CHARLES J. CONNICK : DESIGNER AND WORKER IN STAINED AND
LEADED GLASS : NINE HARCOURT STREET, BOSTON, MASSACHUSETTS

City or Town Cambridge, State Mass. No. 2520
Church Conventual Church and Monastery, Society Date of Completion April 1, 1949
Donor and of S. John Evangelist.
Address _____
Architect Cram and Ferguson. Quality of \$1075 each (\$50 per ft
Glass \$2150 for both.
Denomination _____ Profit 1.135
and Minister _____ \$ 291.93
Footage 43' in the two. sight _____
Sizes, full _____
Ventilators None Set by _____
Position in Church 2 chancel windows - Back of high altar. ("Our Lady" on left
as you face the altar. Protection Glass _____ Groove _____ Stone _____
Height from floor 6' Rabbet _____ Wood _____
Points of compass _____
Quality of light East. See note on back of this sheet about way openings
look.
Inscription None.

The openings look like this standing slightly to the right of the center

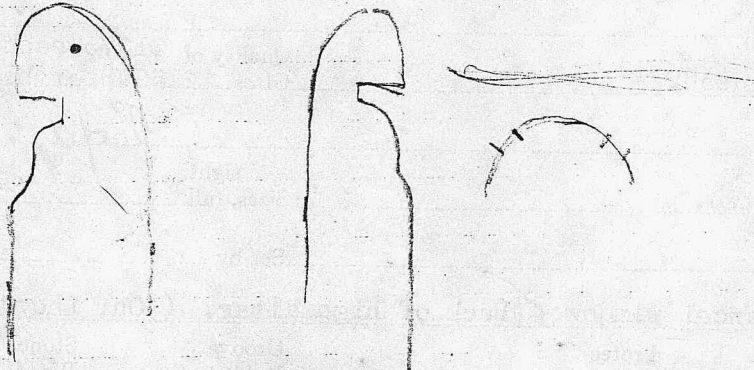
Design wanted now for one - devoted to Our Lady. (The other one will be devoted to Saint John). They want large figures and probably significant medallion below. Would like to keep the figures very formal in Byzantine or Romanesque style. (See Houston, Texas, Annunciation Church.). These windows generally receive little light, but Father Dale says there are times when they get flashes of strong light, from reflections. The panels are about 6' apart. Note: "Our Lady" will be on the left as you face the altar.

Note. July 23, 1947. Father Williams did not care for the suggestion for the Blessed Virgin for the side chancel. He feels very strongly that the figure who still be a little lower in the opening. His first idea that it should be much larger, but I think we persuaded him against this. He would like it well below the brackets, and have a symbol above, perhaps the Crown. Lighter at the top and shading down darker. He thinks the field and border should be very simple. Eliminate the stars and keep the border quieter. We have an inscription that he would like to see worked out in the field below the figure. Inscriptions for both of them in Latin, with perhaps the Latin names going down the sides. He would like to see the figures more in profile, or, at least the head turned three-quarters. He still wants the figures in very archaic rendering. He is not very happy about the ruby field, but I am afraid dark blue would be too sombre. They would like to see more pure blue in these windows to balance the rose and lancets in the opposite end. Keep the field quiet and simple."

Father Dale is not at all pleased with the character of the drawing of the figures in the chancel windows. He feels that they should be much more formal and archaic. Mary's veil looks like white hair. It should be shorter, and much more formalized as in the Houston, Texas windows. He does not like the position of Saint John's hands. This should be restudied. Study the designs from this angle in the full sized drawings, and let Father Dale see them.

Father Dale has in mind something more formal and Byzantine for these chancel windows than was shown in the drawings. Svendsen will work over them some more.

Note: prepare final designs, as planned earlier, with blue background instead of red.
